Advanced Technical Information

Bulletin #: 2227

Taycan - Squeaking Noises from Front Seats

Figure 1 - Felt Application Points

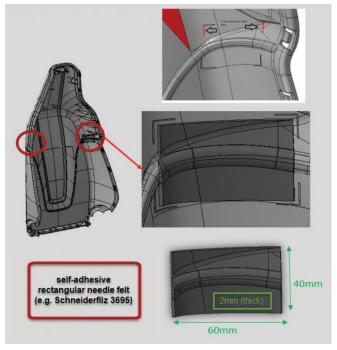
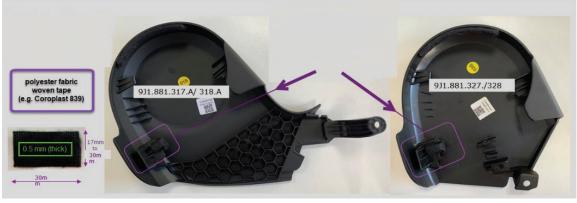
Please apply insulating material to the locations indicated in the photos.
